Replace the existing single glazed sash and case timber windows with double glazed uPVC windows.

At 2F1 3 Gillespie Place Edinburgh EH10 4HS

Application No: 20/00940/FUL

### **DECISION NOTICE**

# 3 Flat 4 Gillespie Place – front window replacement. Flat windows outlined in yellow

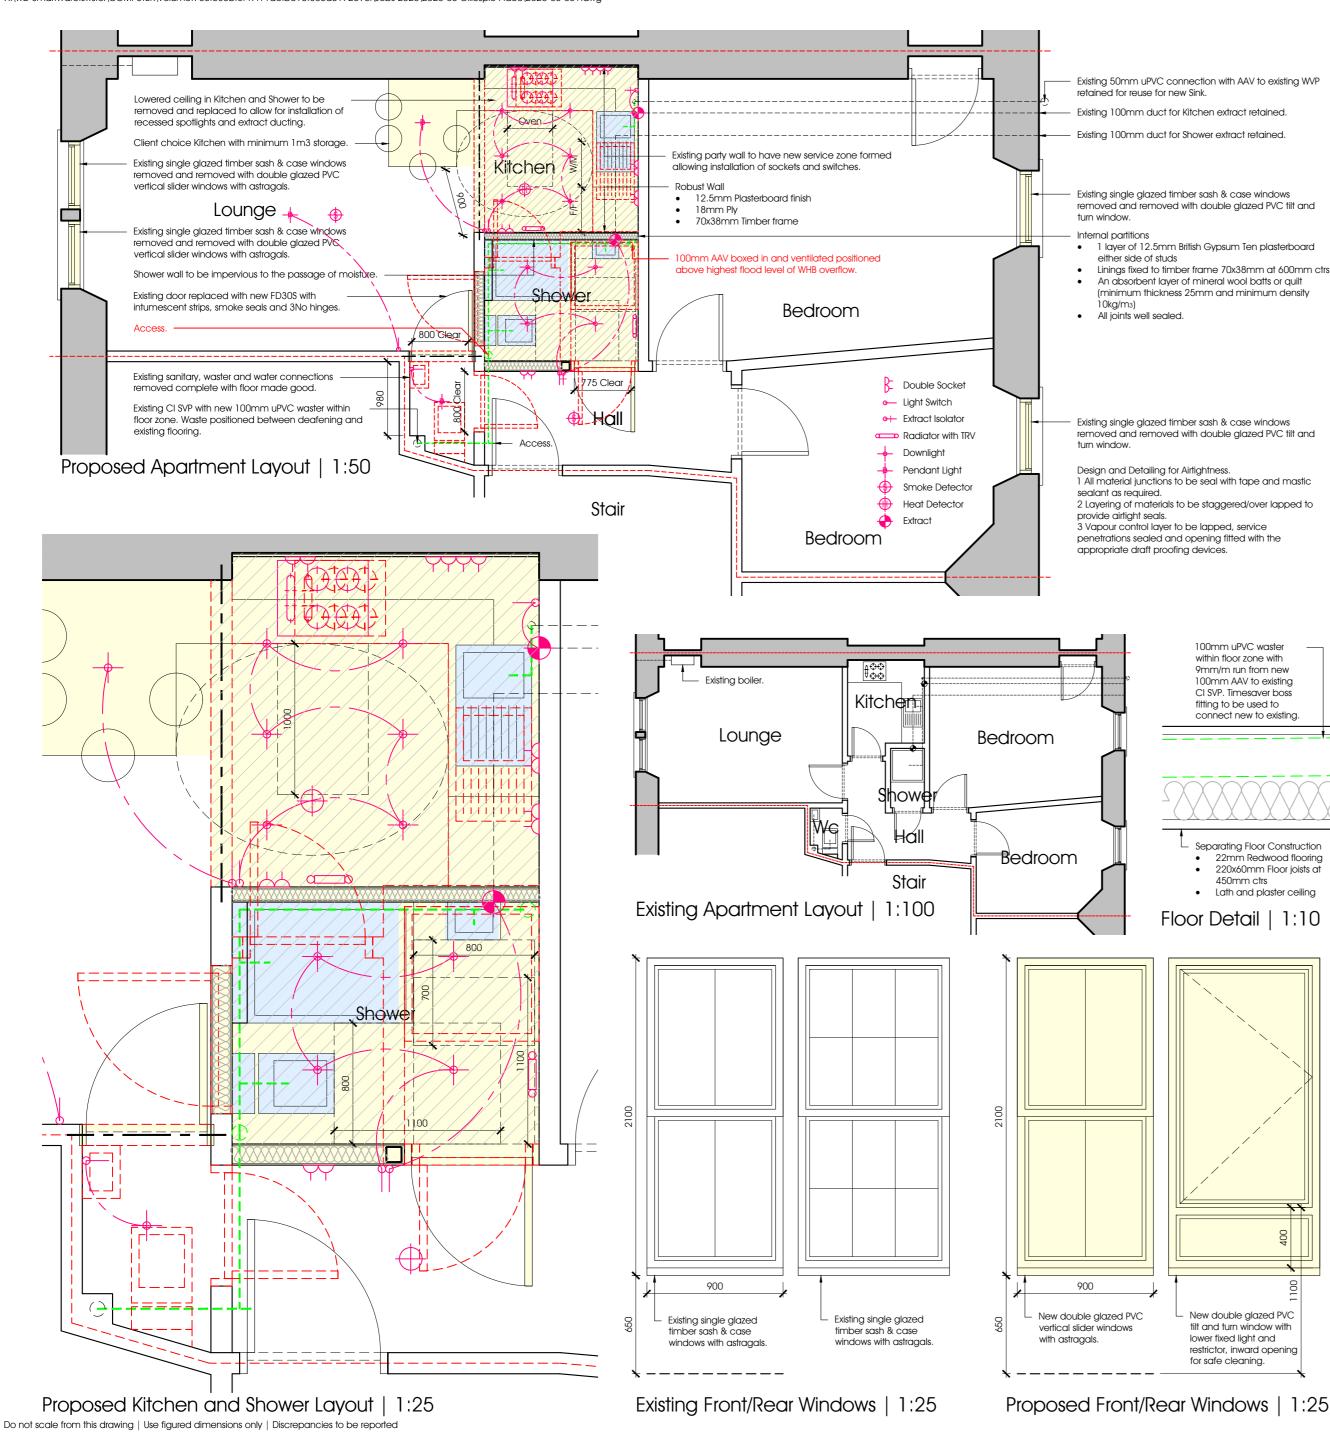
While this is a conservation area, there are a range window types that have been installed on the front of this section of the street – and continue to be varied installations towards Tollcross and Bruntsfield Place.

Proposal is to replace the existing wooden, single glazed windows that are in poor condition with:

White wood effect UPVC sash and case double glazed windows

(within the yellow square noted).

Replacement windows would be Georgian style in keeping with the majority of neighbouring windows and provide greater energy efficiency and noise insulation in the flat.
